SERVICE BULLETIN

GAME: Laser War &amp; Secret Service

#012

SUBJECT: Fuse Change

Power Supply Diagram 55

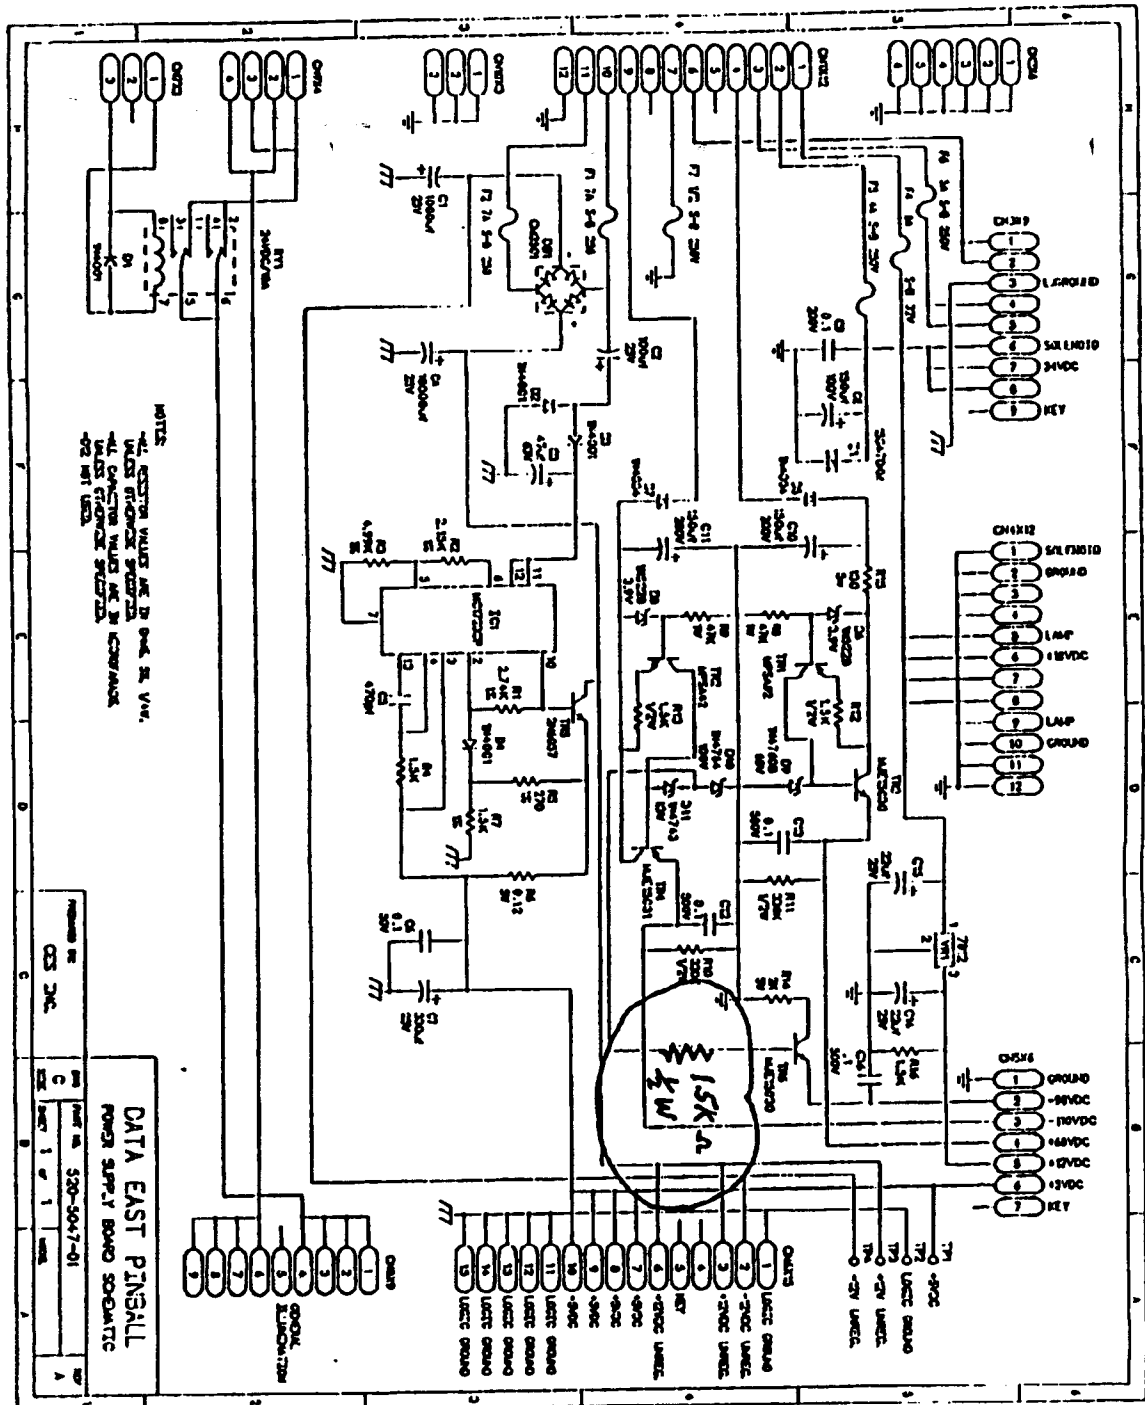
SYMPTOM: Solenoid damage resulting from a shorted driver transistor.

PROBLEM: F-5 on the power supply board is a 5A slo-blo fuse. It should be a Littelfuse 4A slo-blo fuse.

SOLUTION: Change F-5 to a Littelfuse 4A slo-blo fuse.
